**Re: ODOARDI – Vacant Lot
22 Nethermont Ave. – New House Construction
Tax ID: Section 122.16 – Block 4 – Lot 7**

This letter accompanies a revision to the plans, in response to the draft resolution received from the Planning Board Staff and Town Consulting Engineer.

Site Plan and Tree Removal Permit Approvals for

Odoardi [19-039]

FOUNDATION PLAN
SCALE: 1/4"=1'-0"

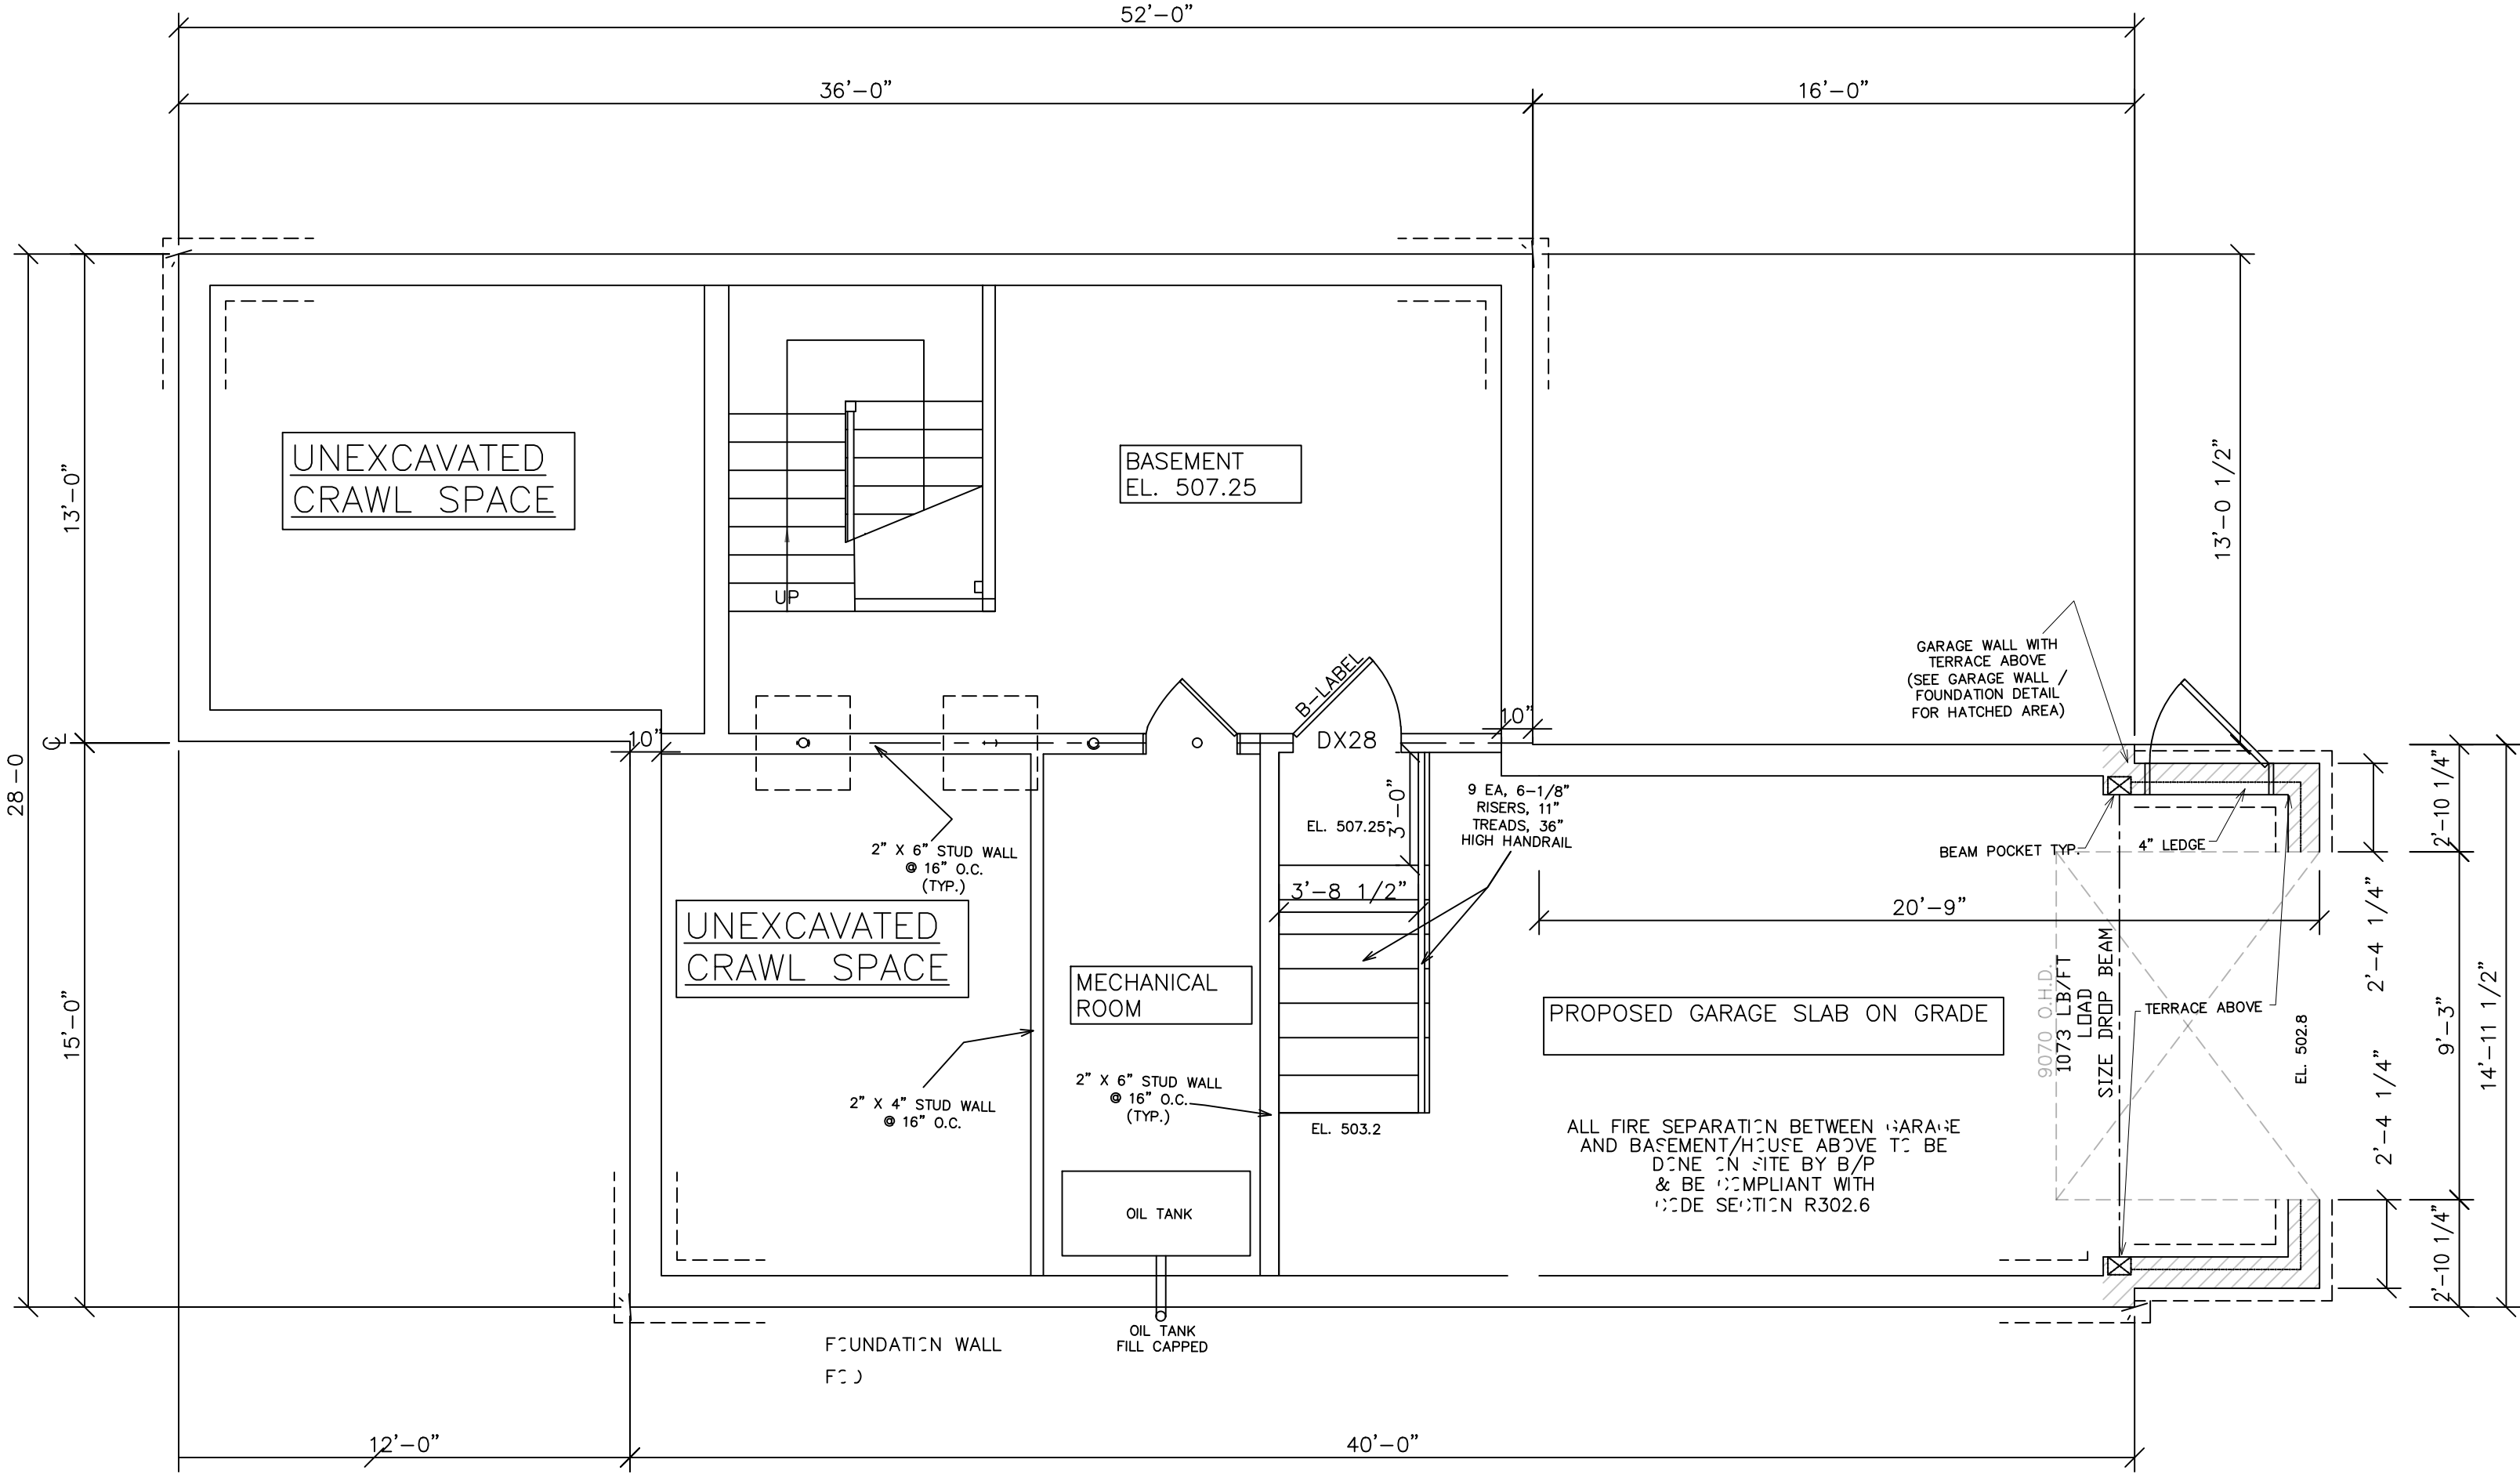
- _____ 17. The garage elevation shown on the plan shall be coordinated with the elevation noted on the driveway profile, to the satisfaction of the Town Engineer.

The garage elevation shown on the basement/foundation plan is 502.8 and matches the driveway profile and site plan.
